DATE: February 17, 2026

PROJECT NAME: River Bend Transit Facility Addition

This addendum forms a part of the bidding and contract documents. This Addendum supersedes and supplements all portions of the original bidding and contract documents dated Jan 20, 2026 with which it conflicts.

**Date:** February 10, 2026**Project:** River Bend Transit – Bus Storage Facility**To:** Paul Newman  
Willett Hofmann, Inc.**Project #:** BI21072**From:** Mike Hessman  
Bill Bruns**Project Location:** Davenport, IA**Addendum Number:** 2

Sheet Number  
**C.09**

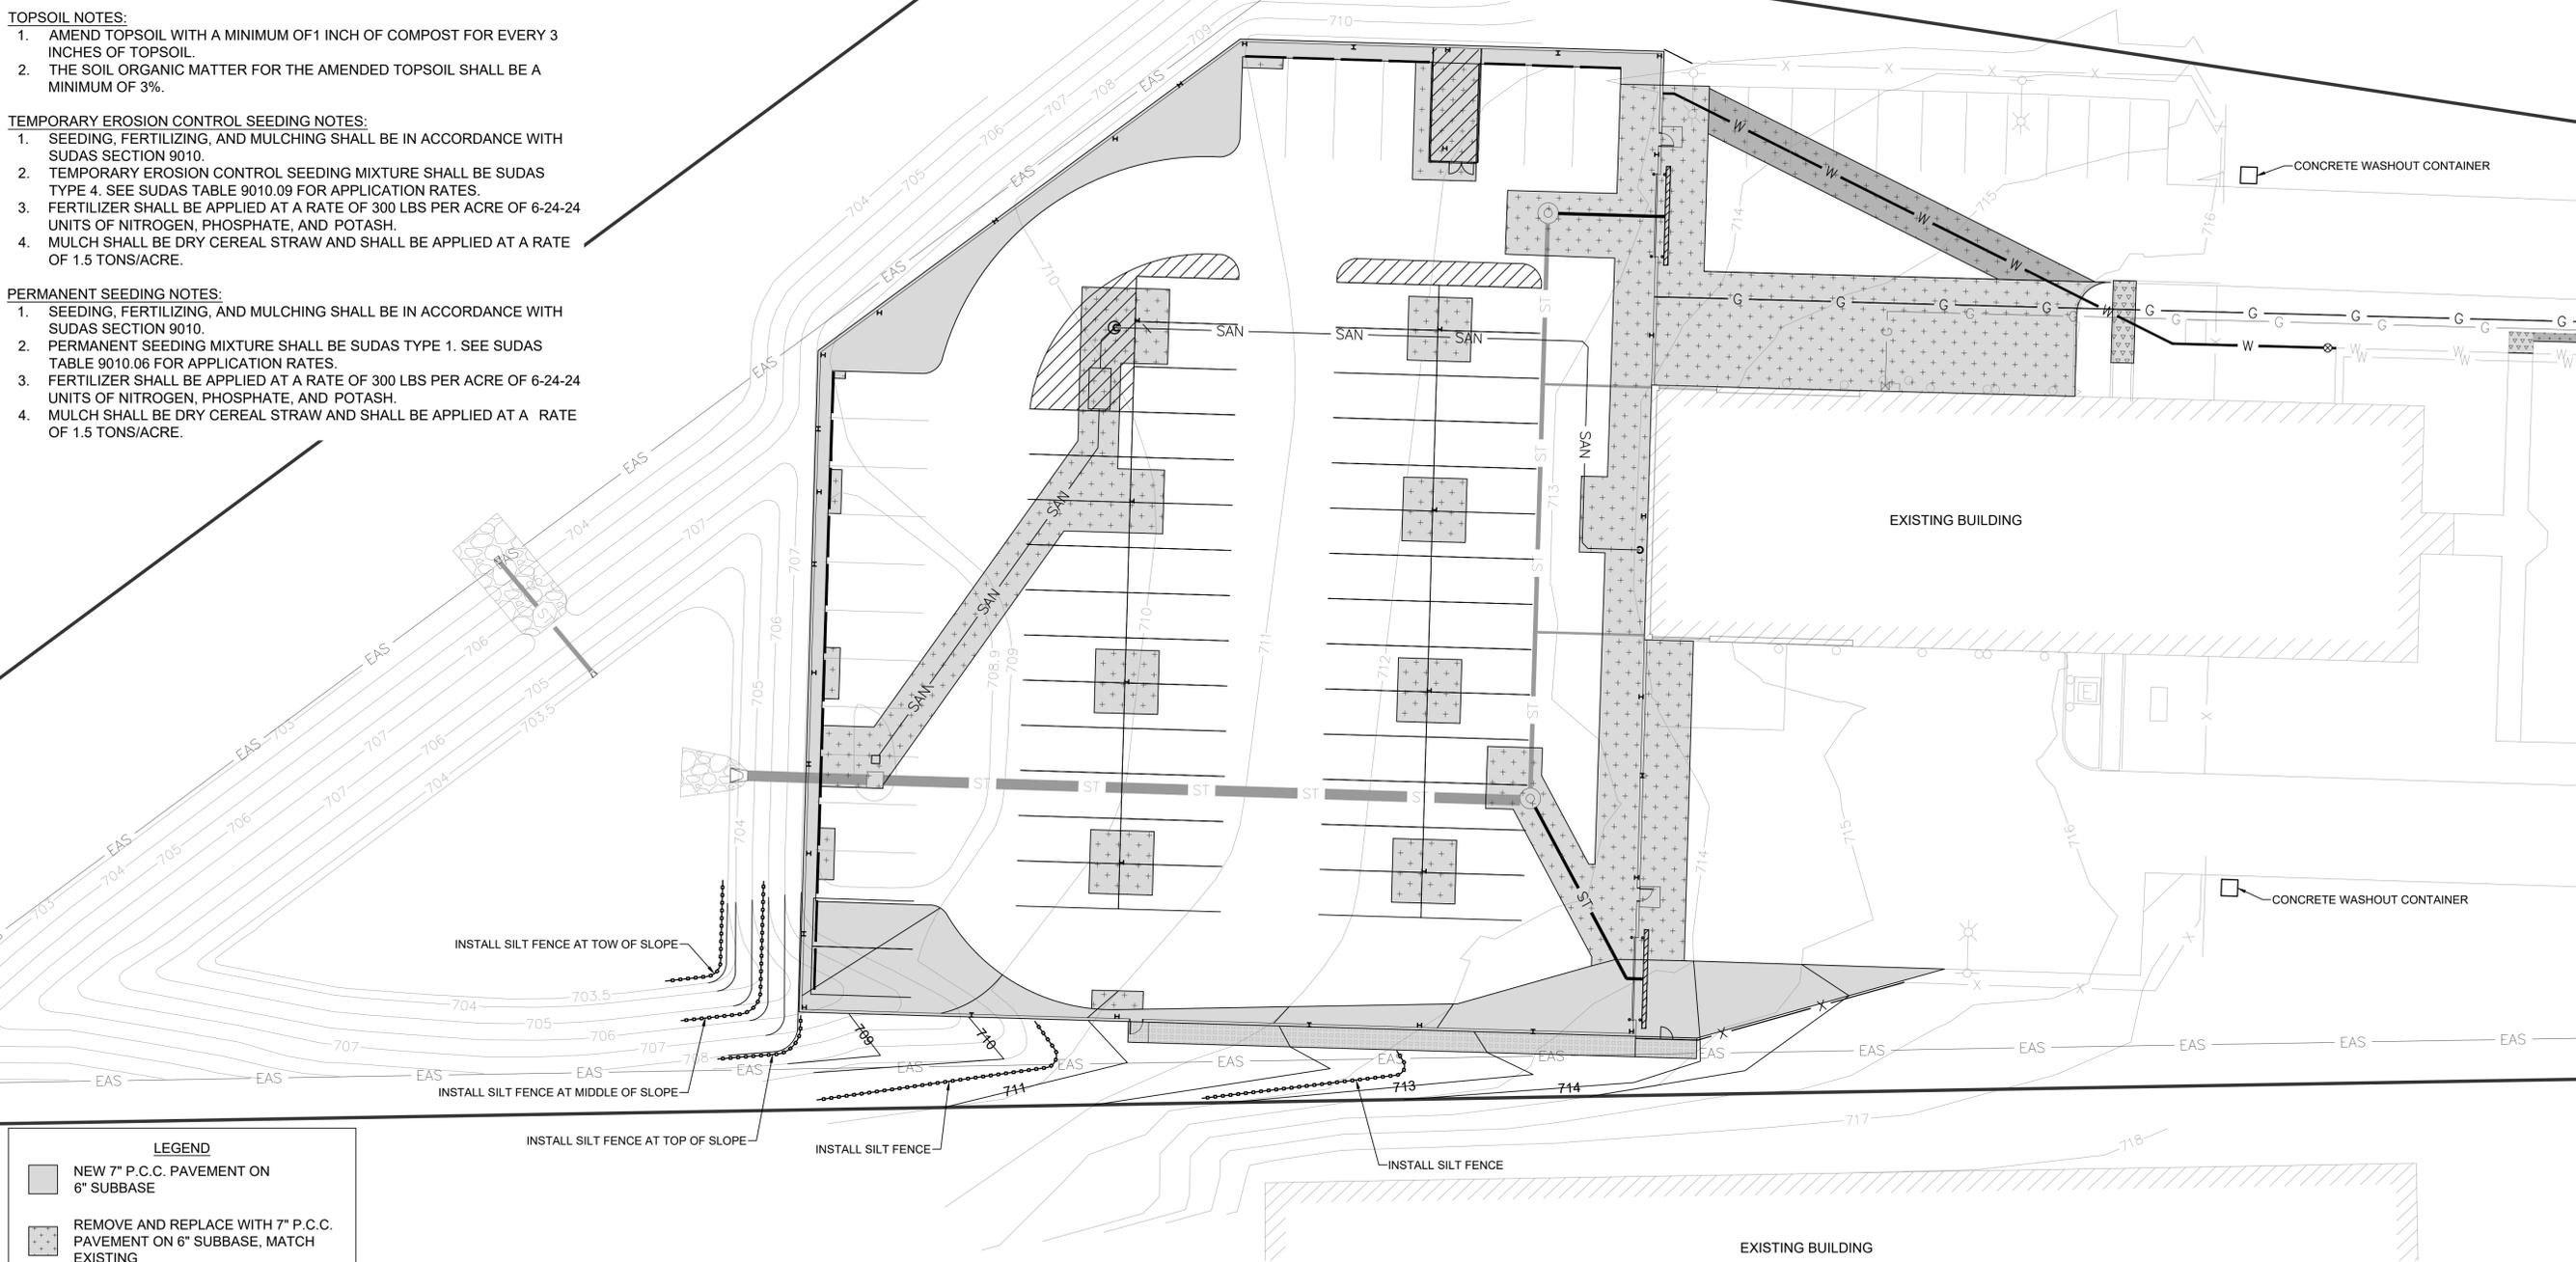
1. **ADD** Sheet C.09 – Erosion Control Plan – See attached.
2. **REVISE** Sheet C.05 – Utilities Plan – See attached.

**S1**

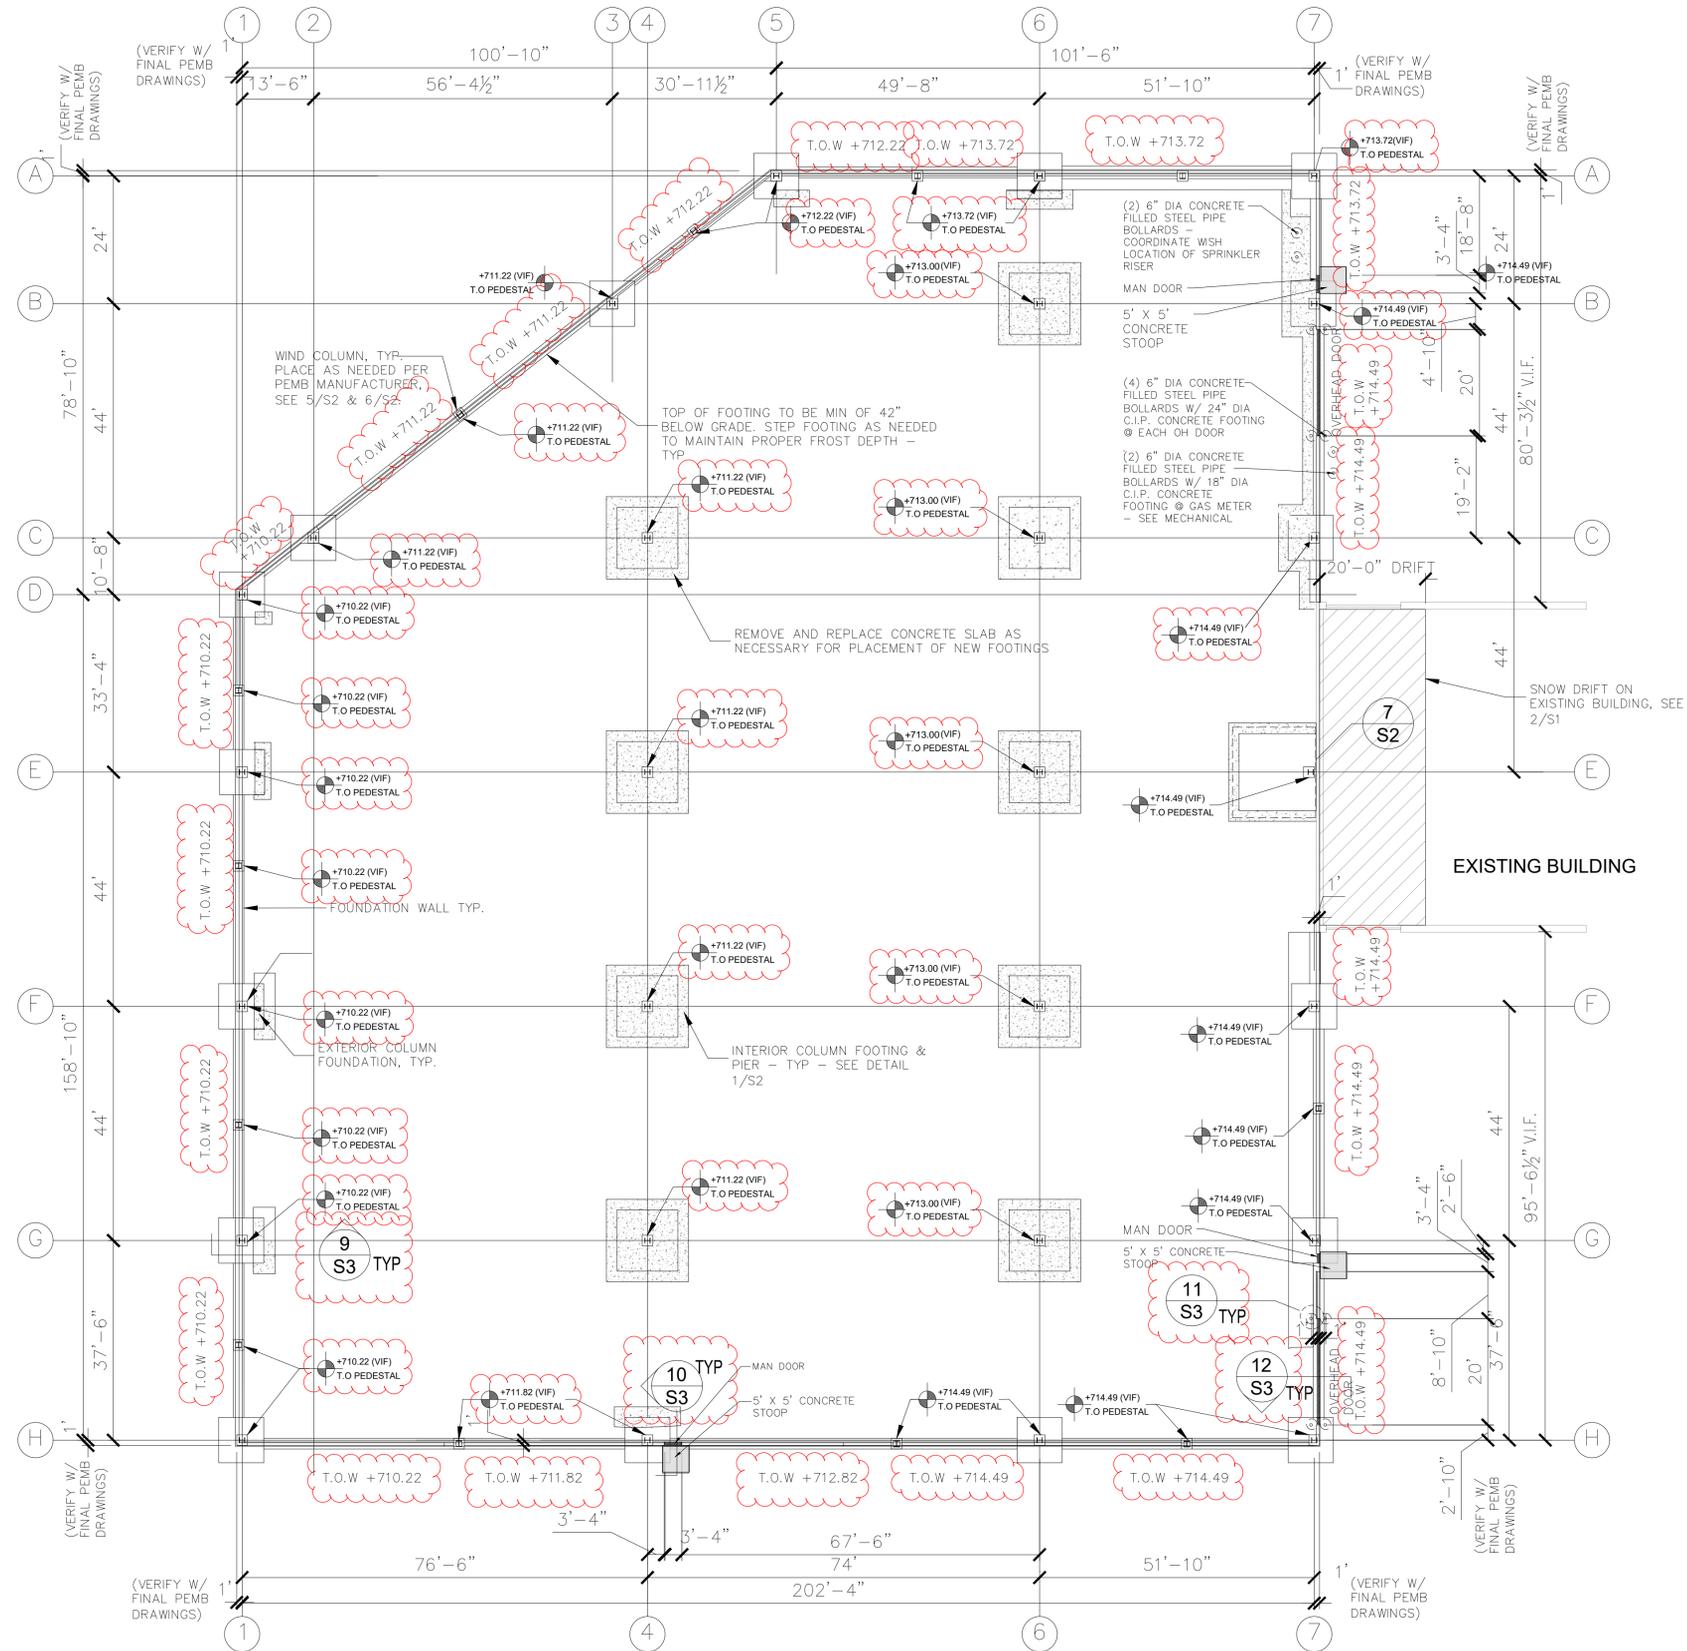
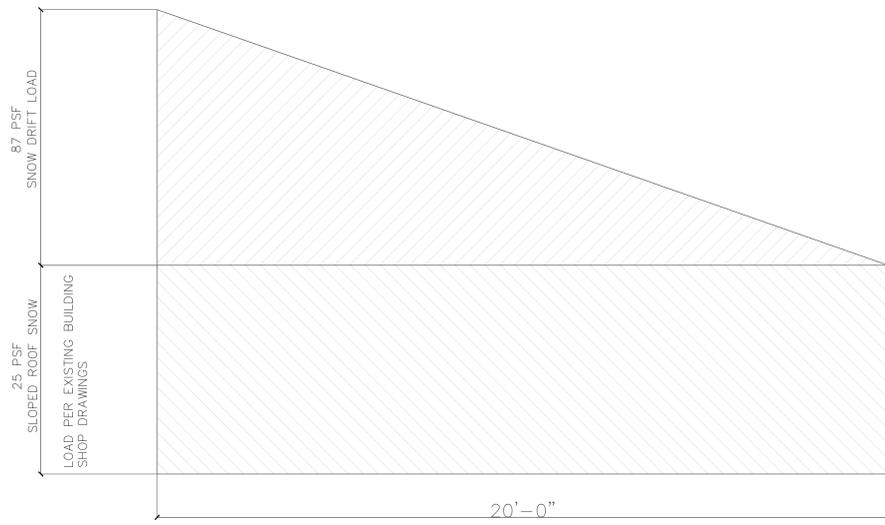
1. **REVISE** Sheet S.1 – Foundation Layout – See attached
2. Sheet S2 – Structural Details
  - a. **ADD** vertical foundation insulation from bottom of slab to top of footing to Details 4/SS2, 6/S2.
3. Sheet S3 – Structural Details
  - a. **ADD** vertical foundation insulation from bottom of slab to top of footing to Details 9/SS3, 10/S3 and 12/S3.
  - b. **DELETE** #4 bars @ 18” OC, in each direction.
  - c. **DELETE** #5 bent bar that connects the infill slab to the foundation wall.
